**KNOWLES GROUP**

**25-27 WARRIEWOOD RD,  
WARRIEWOOD**

**ACCESS REVIEW**

29 August 2017

#### 3.1. Apartment Entrance

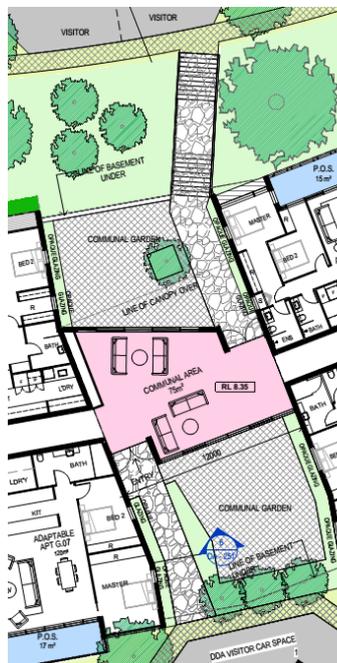
There are 2 main entrances into the apartment building that display the same level of aesthetic.

The eastern entry has appropriate accessibility. There is a wide level accessible pathway that leads past a communal garden to the building entry door. The entry door has suitable accessibility in accordance with AS1428.1:2009 and the DDA Premises Standards. The communal foyer area has appropriate clearances to allow a person in a wheelchair to perform 180° turns in accordance with AS1428.1:2009. There are suitable circulation areas to allow two persons in a wheelchair to pass one another compliant with AS1428.1:2009. There are appropriate accessible paths of travel from the foyer to the passenger lifts on ground floor.

The western entry has stair only access from the pedestrian footpath. There is no wheelchair access at this point. From the information provided by the client, Council does not want ramp construction within the area of the 50 metre creek boundary line. The approach to the building entrance has the same level of aesthetic as the eastern entrance. A stair descends to an entry pathway that leads past a communal garden to the building entry.

- (i) If communication systems such as intercoms are to be provided, they will be located at both eastern and western entrances.

- (ii) The western entry stair is to have handrails on both sides in accordance with AS1428.1 as well as TGSI and indicative step nosings.
- (iii) A performance solution report will be required prior to CC relating to the accessible entrance and its proximity to the western entry.

### 5.2. Adaptable Units G.08 & 1.09

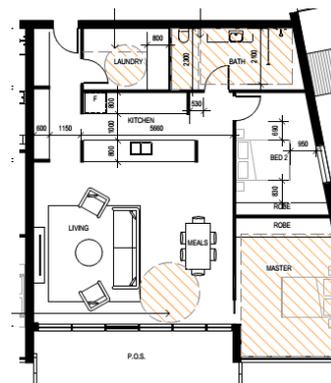
The entry door of the unit achieves 850mm clear width opening (920 door leaf) at pre and post adaptation. Latch side clearance is not achieved at pre adaptation. A performance solution is required.

The kitchen does not achieve 1550mm circulation space outside of the kitchen work spaces at post adaptation. This needs to be modified and can be carried out at design development stage.

- (i) Entry door to allow for the installation of a door powered actuator including service conduits for the doors' operation.
- (ii) All doors to achieve 850mm clear opening width from the outset, compliant with AS1428.1:2009.
- (iii) Allow for the reposition of island kitchen bench to achieve 1550mm between benches. Provide continuous tiling under benches to be relocated and capped off services in the kitchen to achieve low level modification of the kitchen, compliant with AS4299.

#### 5.4. Adaptable Units G.06 & 1.07

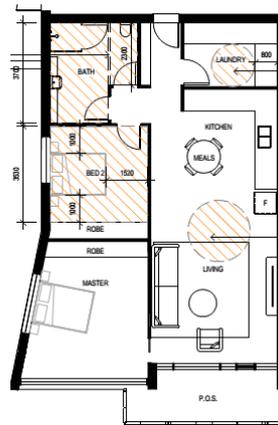
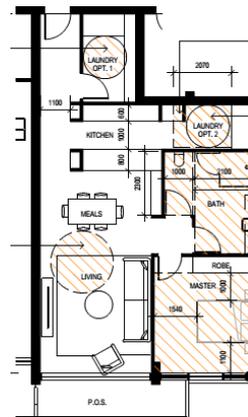
The entry door of the unit achieves 850mm clear width opening (920 door leaf) at pre and post adaptation. Latch side clearance is not achieved at pre adaptation. A performance solution is required.

- (i) Entry door to allow for the installation of a door powered actuator including service conduits for the doors' operation.
- (ii) All doors to achieve 850mm clear opening width from the outset, compliant with AS1428.1:2009.

## **5.6. Adaptable Townhouse TH09 & TH10 Design**

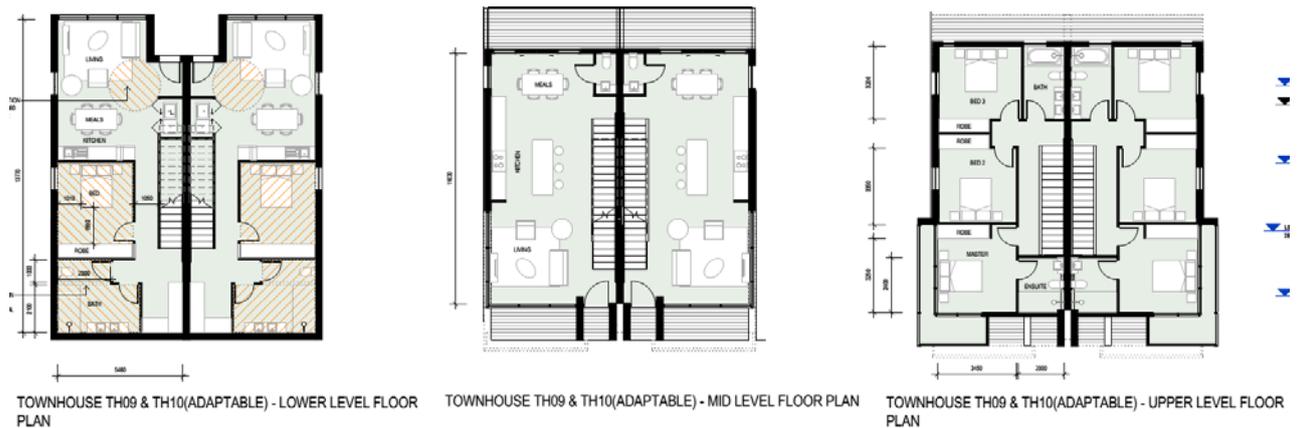
The adaptable townhouse entry level is via the lower level, which has access through the open garage to the street. Whilst this is not a traditional design of an adaptable unit, which has its essential elements accessible from the main entry door.

However in this case, the positioning of the essential elements on lower level is reasonable given the accessibility of the garage and the difficulties that traditional townhouse design faces in complying with AS4299. It is noted that the design has an accessible lift shown between townhouse living area and the garage.

The entry door of the unit achieves 850mm clear width opening (920 door leaf) at pre and post adaptation. Latch side clearance is not achieved at pre adaptation. A performance solution is required.

- (i) Ensure the lift from garage to lower level is installed prior to OC.
- (ii) Entry door to allow for the installation of a door powered actuator including service conduits for the doors' operation.
- (iii) All doors to achieve 850mm clear opening width from the outset, compliant with AS1428.1:2009.
